Representation on behalf of the residents of 20 Cecil Road in objection to AWDM/0388/26 Planning application for a two storey side extension, single storey rear extension and rear dormer at 22 Cecil Road, Lancing, BN15 8HN.

I write in my capacity as Director of **LF Architecture Ltd** on behalf of my clients, the residents of **20 Cecil Road**, who are the adjoining occupiers directly affected by the proposed development at **22 Cecil Road**.

Extract from drawing 05 – First Floor AS Proposed showing 2no. first floor bathroom windows in the North Elevation

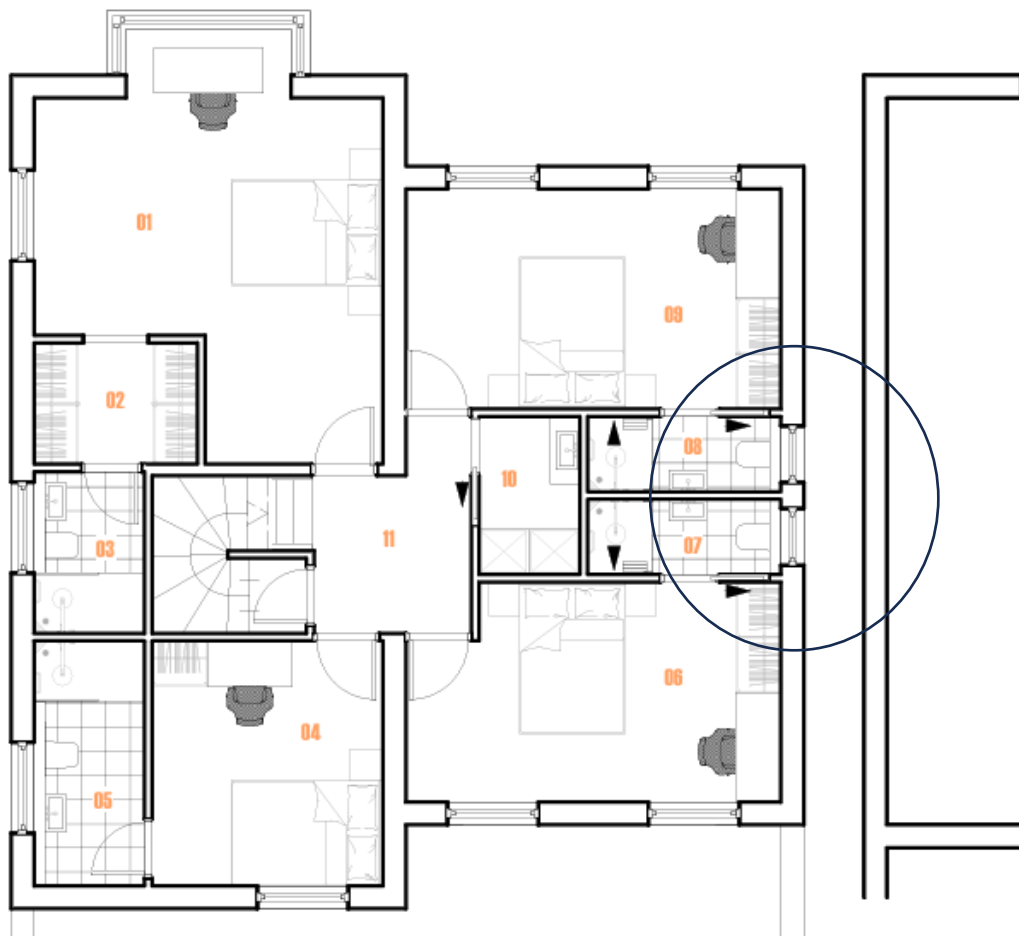
There is also an inconsistency between the submitted drawings. Drawing 05 appears to show proposed first-floor bathroom windows on the north elevation facing towards No. 20. However, those windows appear to be omitted from the proposed north elevation on Drawing 11. This is a material inconsistency because the north elevation directly affects my clients' property and is relevant to privacy, overlooking and the proper assessment of the side elevation.

The Council should not determine the application on inconsistent drawings. The applicant should be required to submit corrected drawings showing the proposed north elevation accurately, including all proposed first-floor windows and any changes to eaves, wall or roof height.

The inconsistency between Drawing 05 and Drawing 11 makes this issue more significant. If the windows are proposed, they must be shown accurately on the north elevation and controlled by condition. If they are not proposed, the first-floor plan should be corrected.

Although these windows are understood to serve bathrooms, they are upper-floor side elevation windows facing towards the neighbouring property. To protect the privacy of No. 20, the drawings should clearly confirm that these windows will be obscure glazed and either fixed shut or only openable above 1.7m above internal finished floor level.

If the Council is minded to grant permission, my clients request that a condition is imposed requiring any proposed first-floor bathroom windows in the north elevation to be obscure glazed to a minimum privacy level 3 and either fixed shut or restricted so that no opening part is below 1.7m

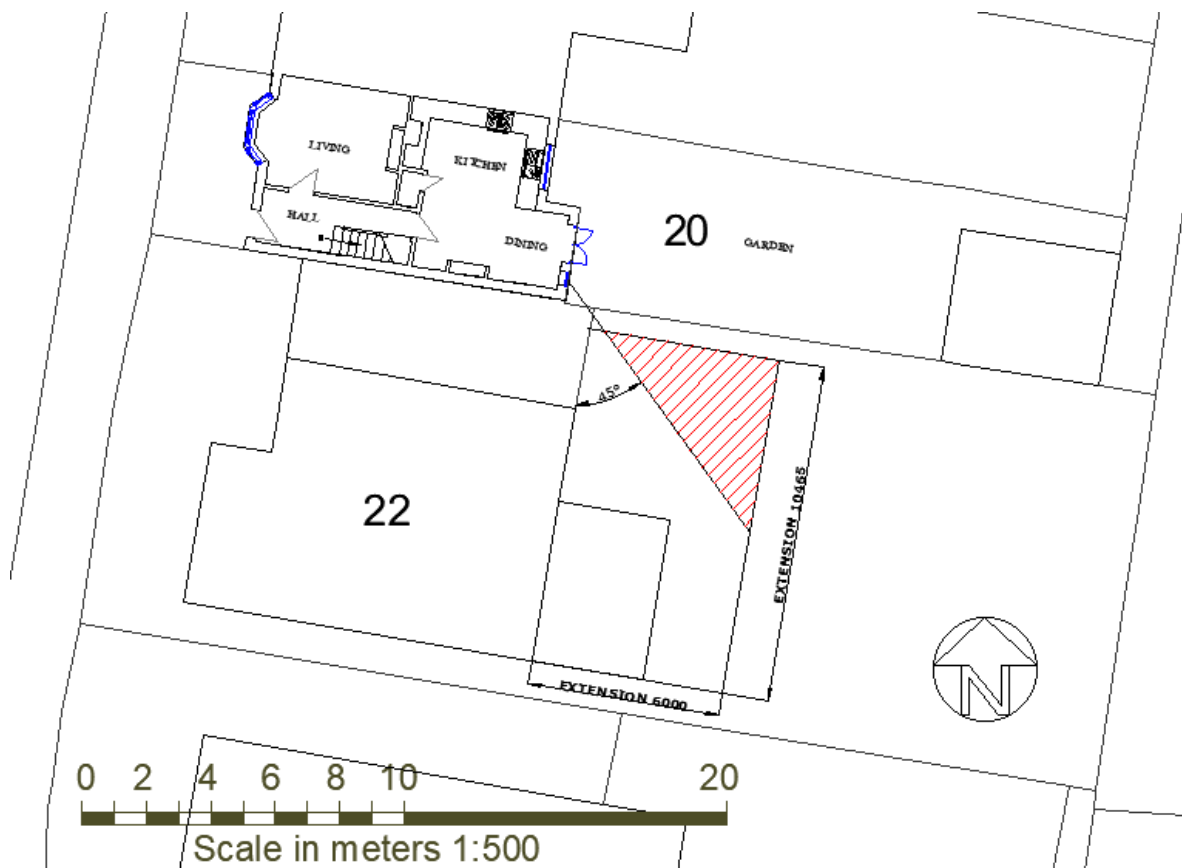
Having reviewed the submitted drawings and the relationship between the properties, the proposed single-storey rear extension appears to project beyond the 45-degree daylight / outlook line when assessed from the dining room window at No. 20. The extent of the projection is material. It is not a minor technical issue. It indicates likely harm to the amenity of No. 20 through loss of daylight, reduced outlook and increased enclosure.

The orientation of the properties increases the concern. The proposed rear extension would be positioned directly to the south of No. 20. As a result, the projection beyond the 45-degree line is likely to have a greater impact on daylight and sunlight to the dining room window and French doors than would be the case if the extension were located on a less sensitive orientation. This reinforces the need for the Council to treat the impact on No. 20 as material planning harm.

The area of the proposed extension shown hatched in red on the OS plan below indicates the extent of the proposal that would project beyond the 45-degree daylight / outlook line when assessed from the dining room window at No. 20 Cecil Road. This supports my clients' objection that the proposal would cause unacceptable harm to their residential amenity through loss of daylight, reduced outlook and increased enclosure.

The separation distance also increases the concern. The proposed side wall of the rear extension running parallel with No. 20 would be approximately 800mm from my clients' property. This creates a very tight relationship between the proposed built form and the neighbouring dwelling. In combination with the projection beyond the 45-degree line and the southerly position of the extension, the 800mm separation would materially increase the sense of enclosure and the likely loss of daylight, sunlight and outlook to the dining room window and French doors at No. 20.

In the alternative, the proposal should be amended so that the single-storey rear extension does not project beyond the 45-degree daylight / outlook line from the dining room window at No. 20 and adequate parking provision is retained or properly justified.
